SUBDIVISION REVIEW SHEET**CASE NO.:** C8-2018-0122.4A**COMMISSION DATE:** April 20, 2021**SUBDIVISION NAME:** EastVillage Single Family Phase 4 Final Plat**ADDRESS:** 4605 E Howard Ln**APPLICANT:** RH Pioneer North, LLC (Annie Atkinson)**AGENT:** T. Walter Hoysa, P.E. (LJA Engineering, Inc.)**ZONING:** PUD**NEIGHBORHOOD PLAN:** N/A**AREA:** 10.69 acres**LOTS:** 63**COUNTY:** Travis**DISTRICT:** 1**WATERSHED:** Harris Branch (Suburban)**JURISDICTION:** Full Purpose**SIDEWALKS:** Sidewalks will be constructed along Syndicate Rd, Cobalt Ln, Oxford Vineyard Ln, Poco Dr and Pear Light Rd.**DEPARTMENT COMMENTS:**

**CITY OF AUSTIN –DEVELOPMENT SERVICES DEPARTMENT
SUBDIVISION APPLICATION – MASTER COMMENT REPORT**

CASE NUMBER: C8-2018-0122.4A
 UPDATE: U0
 CASE MANAGER: Joey de la Garza PHONE #: 512-974-2664

PROJECT NAME: East Village Single Family Phase 4
 LOCATION: 3407 E HOWARD LN

DRAWING NAME: EASTVILLE PH 4
 SHEET 01 of 02

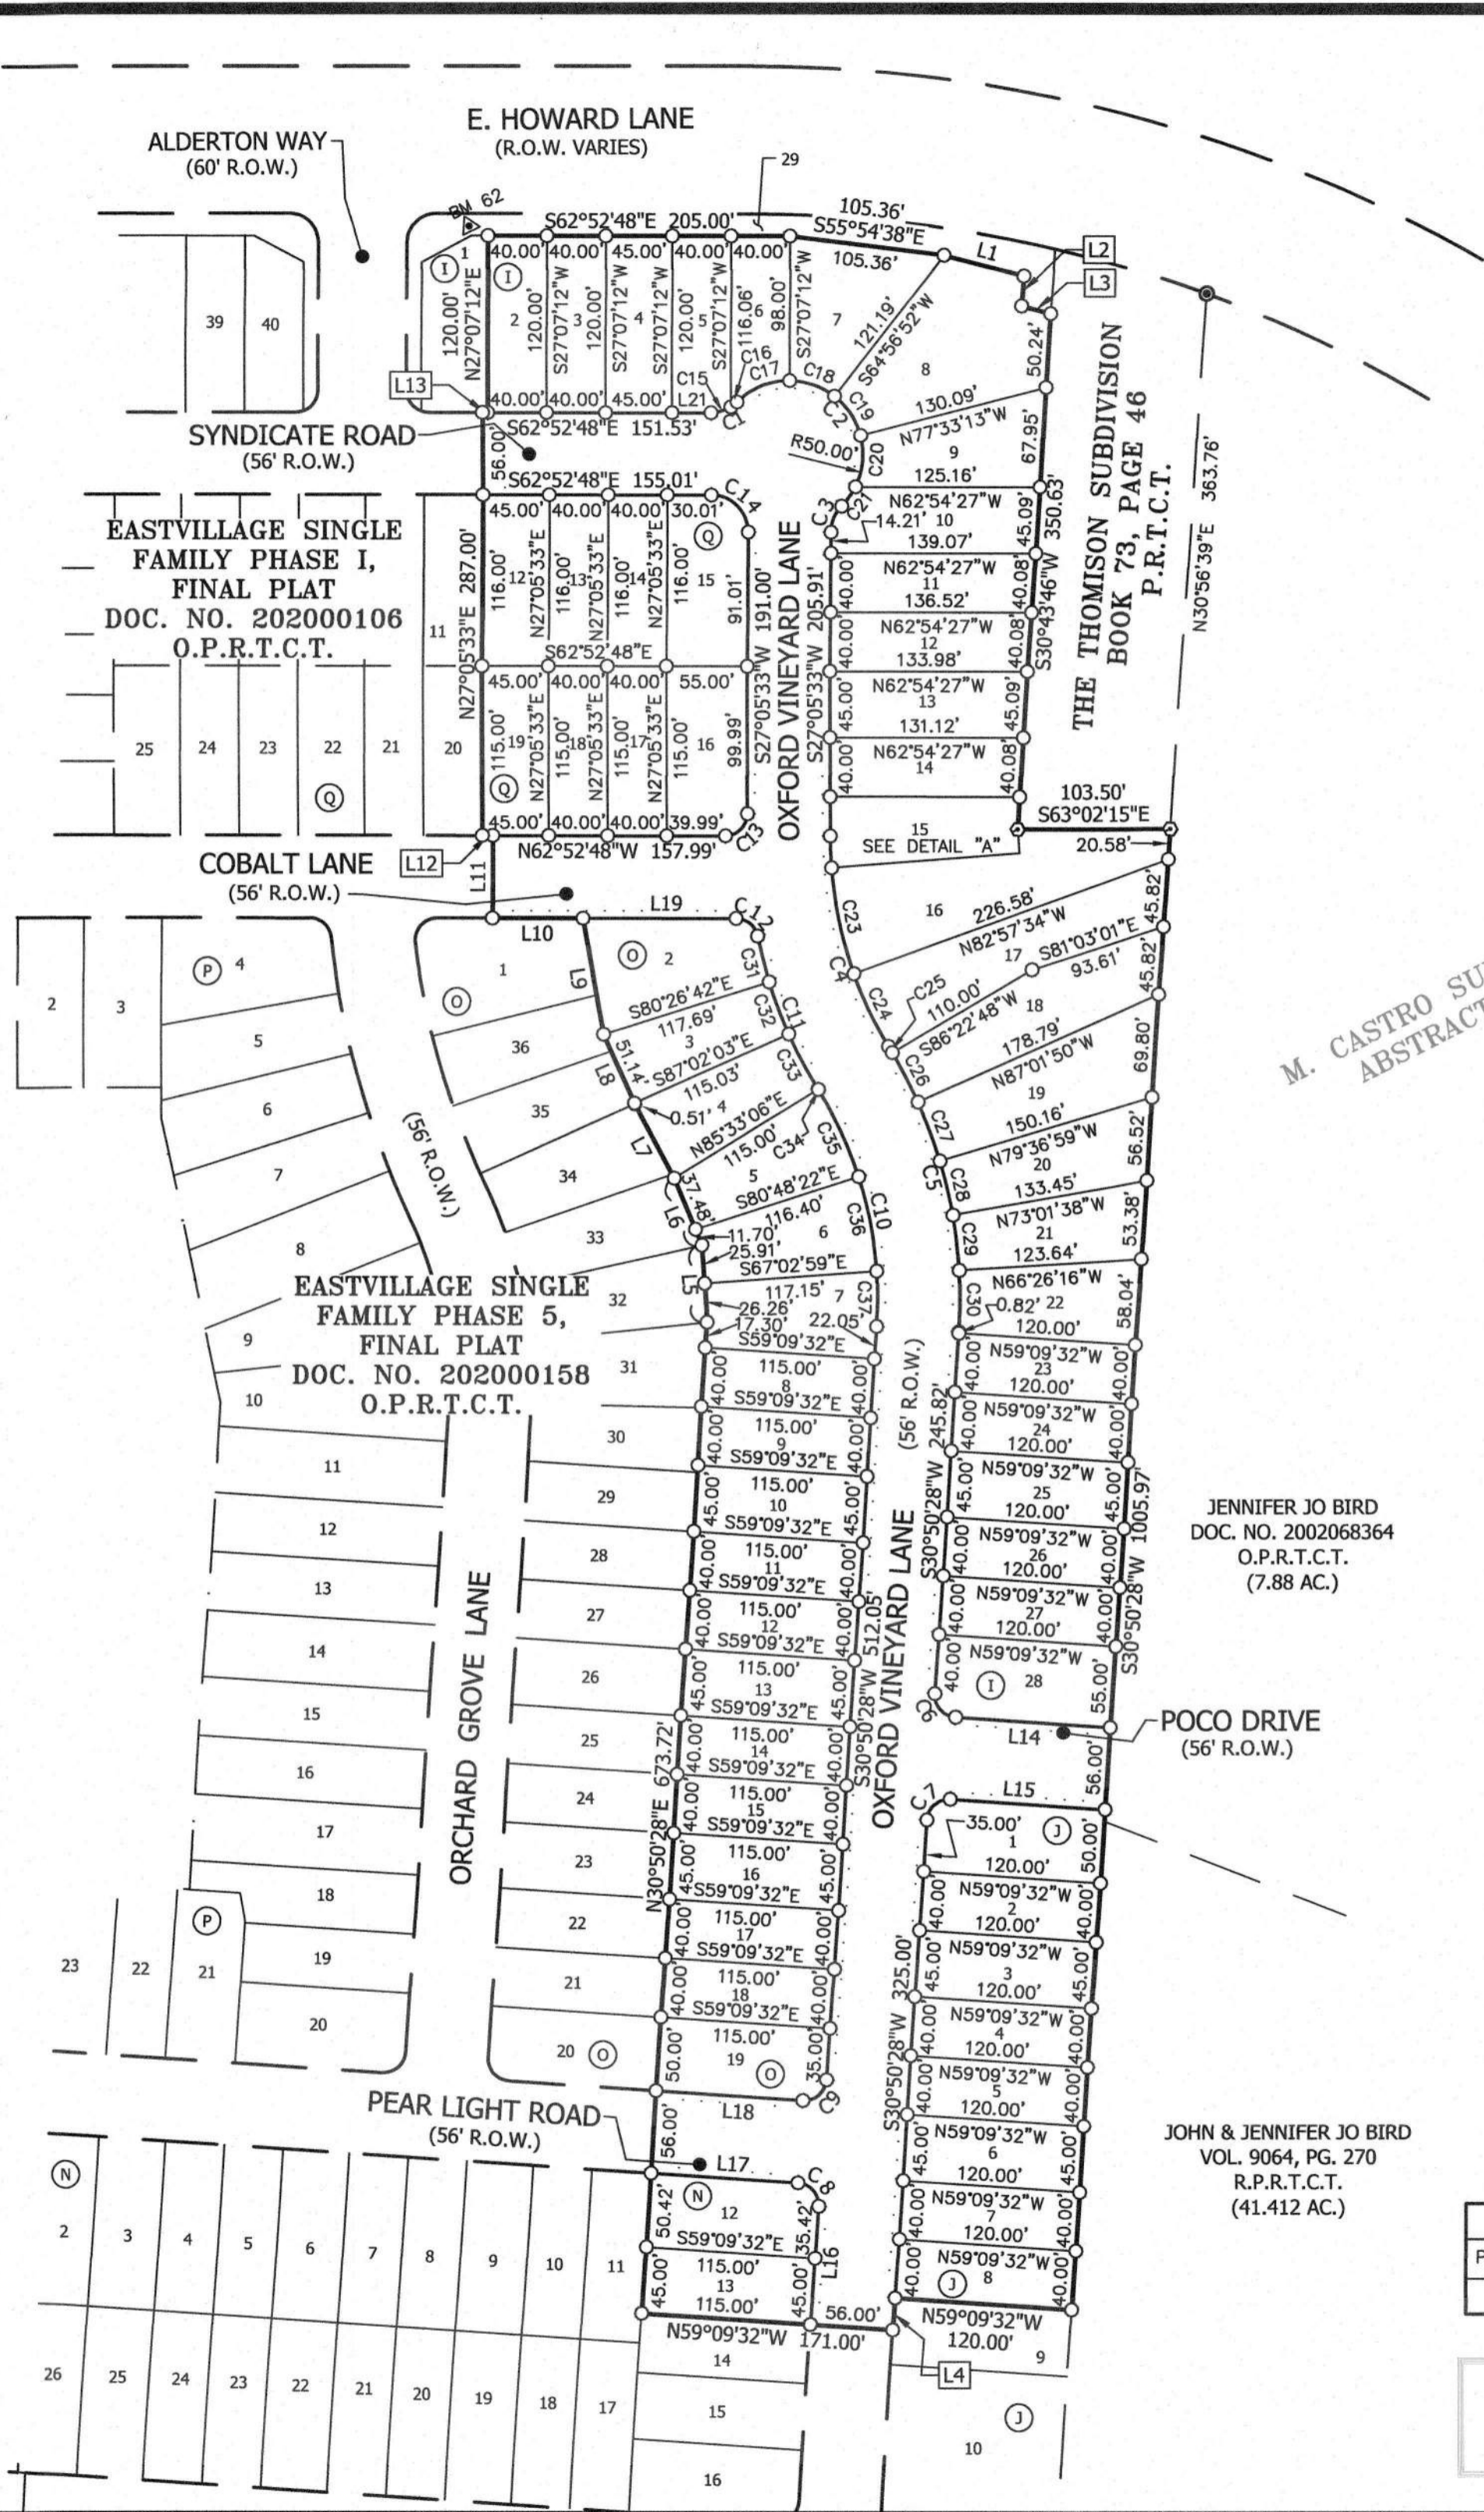
AD2: Please update E HOWARD LN label and remove any punctuation marks or points

SR 1. Add the Case #C8-2018-0122.4A in the bottom right hand corner of each sheet. 25-1-83

SR 2. Please remove the application submittal date and plat preparation date from the Land Use Summary box on Sheet 1. 25-1-83

SR 3. Submit a drawing that shows the final plat in relation to the entire preliminary plan. 25-1-83

SR 4. One concrete monument is required to be placed at or near a major property corner if one is not located and shown within 1300 feet on previously recorded property. 25-4-131
